Meghna Knit Composite Meghna Dresses Ltd

Gilarchala, Sreepur, Gazipur, Dhaka
(+24.1861°N, 90.4254°E)

3 November 2013

Soils Report

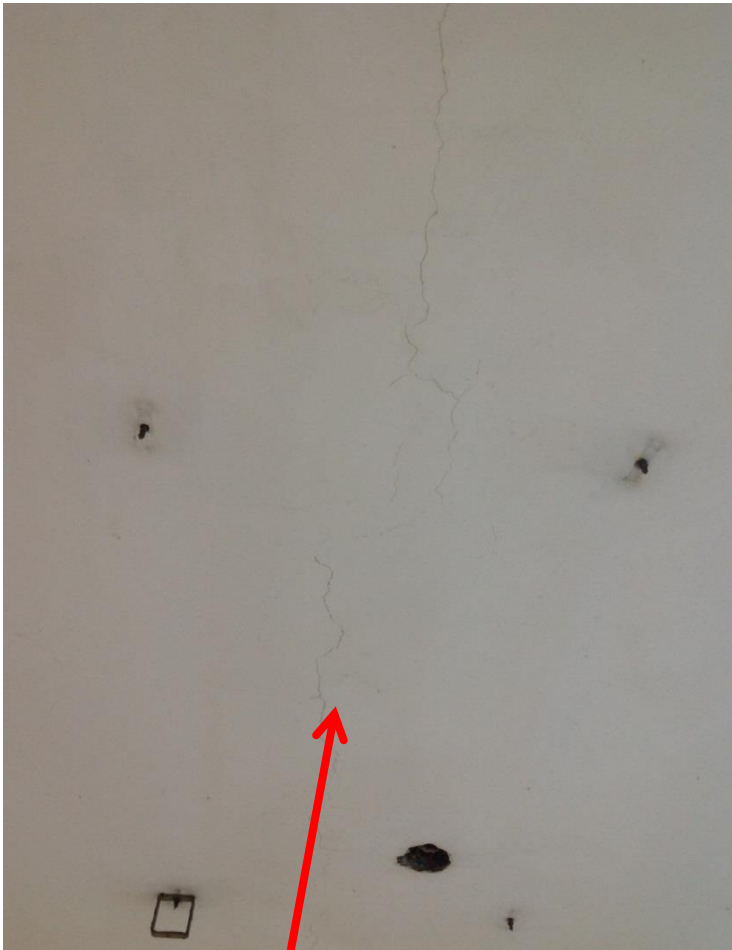
2013 Soils Report provided – Recommendations and assumptions within the report must be reviewed by Building Engineer to ensure that these have been considered in the design calculations for the building foundations

Item No.	Observation	Recommended Action Plan	Recommended Timeline
4	Soils Report carried out in 2013.	Building Engineer to review Soils Report to confirm that the geotechnical design criteria have been fully complied with in the original design of the factory.	6-Months
5	Hairline cracks in beams and slab on soffit of 3rd floor	Sections of plaster finish to beams and slab to be removed to investigate if cracks penetrate the building structure.	6-Weeks
6	Hairline cracks in beams and slab on soffit of 3rd floor	Building Engineer to carry out design check on beams and slabs to confirm that these cracks are non-structural.	6-Months
